Company	Trenz Electronic GmbH
PCN Number	PCN-20201012
Title	KK0808-03 to KK0808-05 Hardware Revision Change
Subject	Hardware Revision Change
Issue Date	2020-10-28

2.2 #2 Added two more M3 mounting holes.

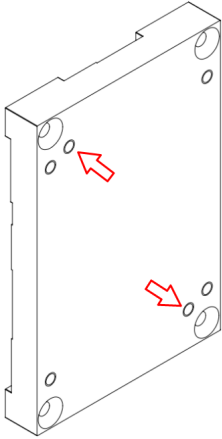
Type: Hardware change

Reason: Make compatible to an active cooler of the shelf.

Impact: The Heatspreader is compatible with SZ05L from RADIANT HEATSINKS.

Models with 2 additional threads are revision 05.
